Product Change Notification

Change Notification #:	819816-00
Change Title:	Select Intel® Ethernet Controllers and Intel®
	Ethernet Connections,
	PCN 819816-00, Transport Media,
	Update Tape & Reel Intermediate Box IPN
	A22675-001 with Graphic Artwork, Intel Logo &
	Barcode
Date of Publication:	April 12, 2024

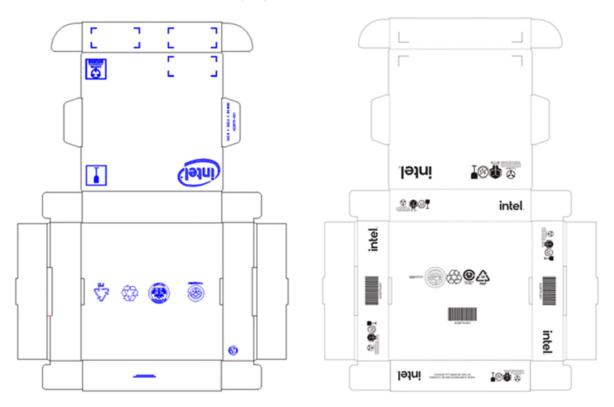
Intel will update the Tape & Reel Intermediate Box used in transport of materials, making the following four appearance changes:

- 1. Adding an IPN barcode for customers to scan
- 2. Replacing older Intel Logo with newer Intel Logo
- 3. Updating packaging symbols with new symbols
- 4. Changing the color of the graphic artwork ink from blue to black

As-Is: IPN A22675-001 Artworks, color (blue)

To Be: IPN A22675-001 Artwork, color (black)
